UNITED STATES PATENT AND TRADEMARK OFFICE

APPLICATION NO.	FILING DATE	FIRST NAMED INVENTOR	ATTORNEY DOCKET NO.	CONFIRMATION NO.
10/773,631	02/06/2004	Alexander Star	612407-23	8346
23879	7590	11/01/2006		
BRIAN M BERLINER, ESQ O'MELVENY & MYERS, LLP 400 SOUTH HOPE STREET LOS ANGELES, CA 90071-2899			EXAMINER SINES, BRIAN J	
			ART UNIT	PAPER NUMBER
			1743

Office Action Summary

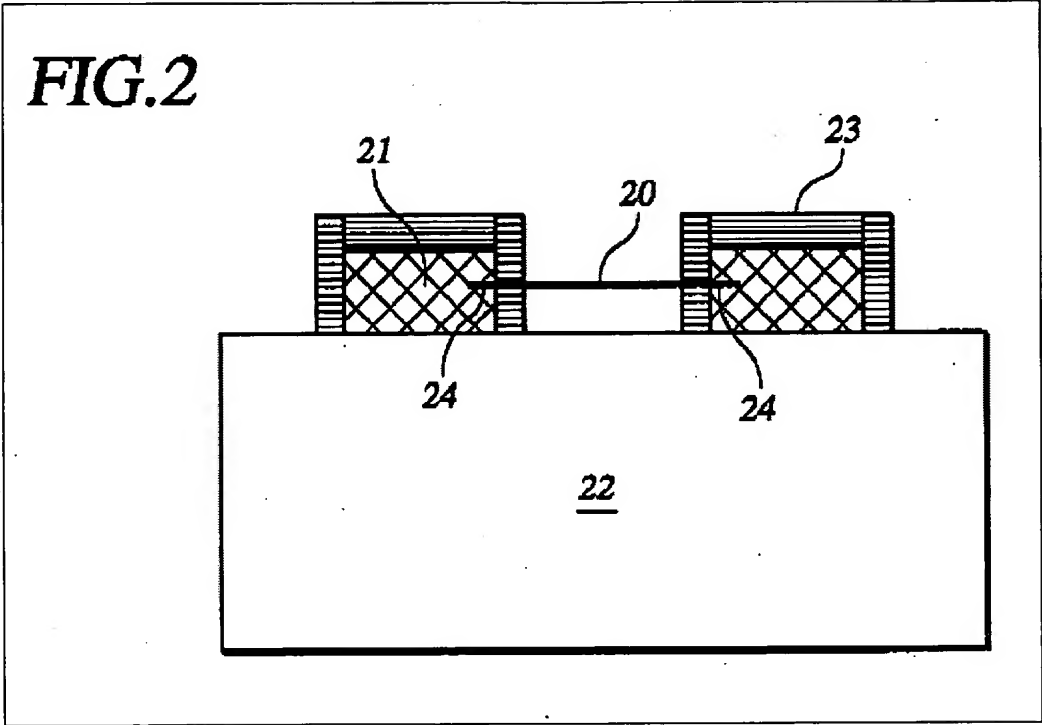
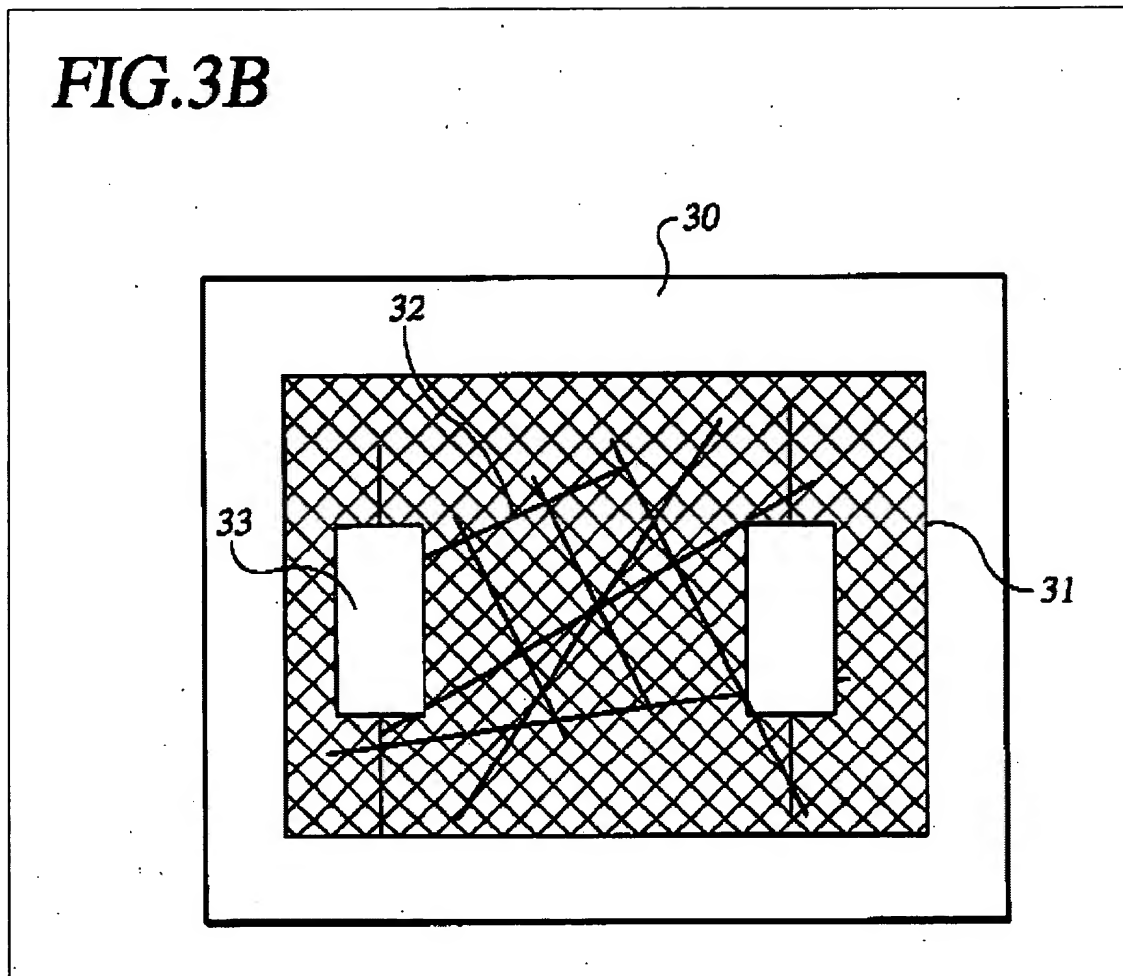
Regarding claims 1 and 2, Dai teaches an apparatus comprising: a substrate 22, 30; at least one nanotube 20, 32 disposed on the substrate; at least one electrical contact 23, 33, wherein the contact is in electrical communication with the at least one nanotube (see figures 2 and 3B; col. 4, lines 23 – 65).

Regarding claim 3, as shown in figures 2 and 3B, the nanotube 20, 32 spans the distance between two electrical contacts 23, 33.

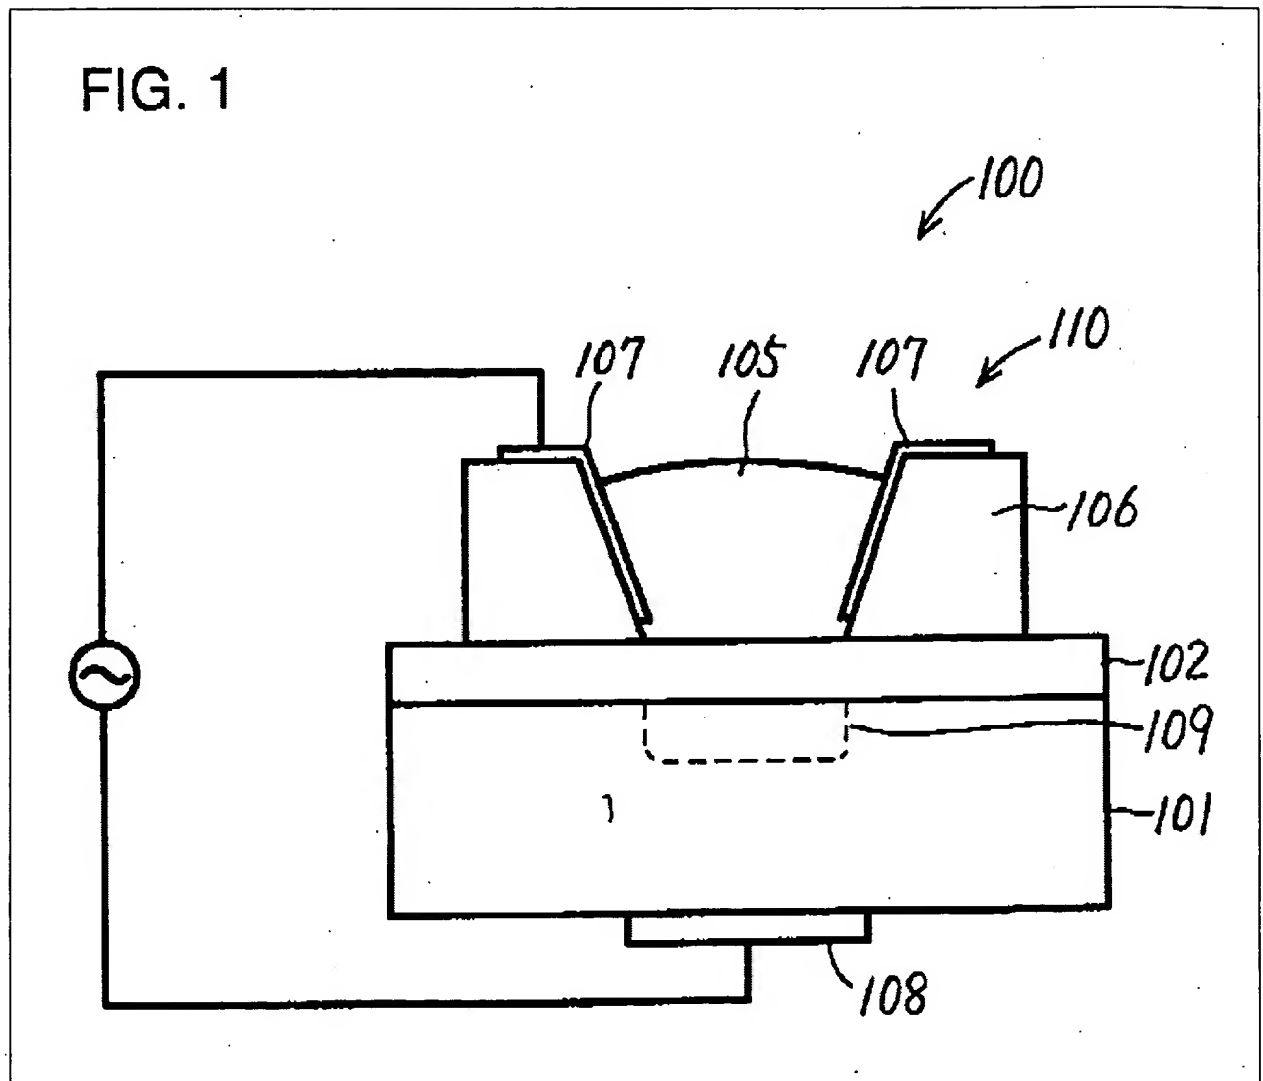
Dai does not specifically teach the incorporation of a sample exposure portion to maintain a liquid analyte sample in contact with at least one nanotube. However, the use of containing means for holding a sample for analysis with sensing devices is considered well known in the art (see MPEP §2144.03). For example, Akioka teaches a sensing device comprising a sample exposure portion (e.g., storage part 110) with electrical contact 107 for sensing the solution 105 (see, e.g., col. 2, lines 15 – 28; figure 1).
